**Amendments to the Drawings:**

S/N 10/714,812

Amdt dated April 21, 2006

Annotated Drawing

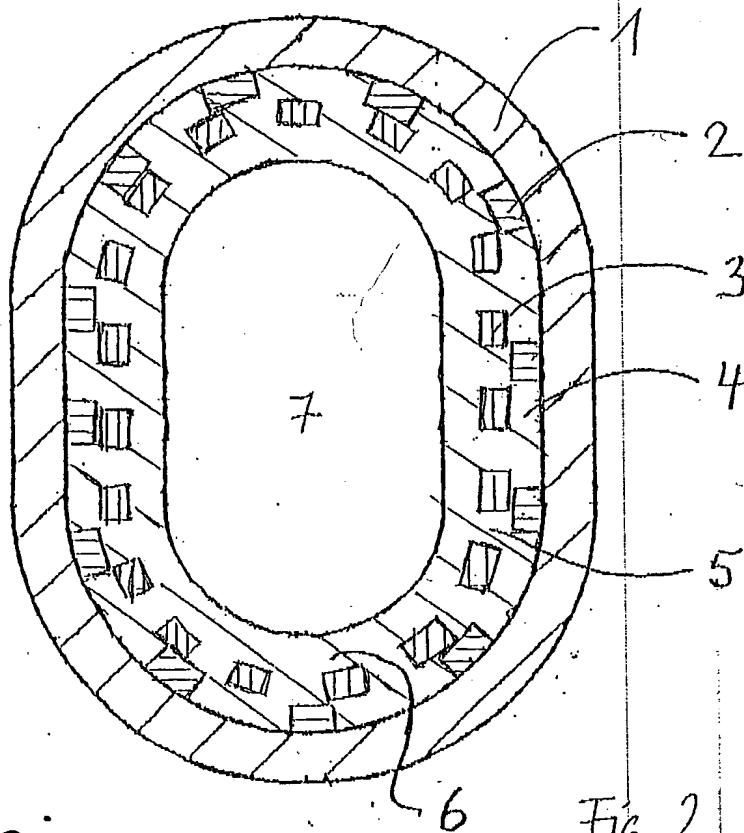
The attached sheet of drawings includes changes to Fig. 2. This sheet replaces the original sheet of Fig. 2. In Fig. 2, shading has been added to indicate elastomeric material.

With regard to the objections to the drawings, a new Fig. 2 is being submitted herewith in which the lining (6) has been shaded to represent elastomeric material. With this change to the drawing, it is believed that the apertures (4, 5) are clearly shown to be filled by the material of the lining (6).

Elastomeric  
material  
shading added in lining 6
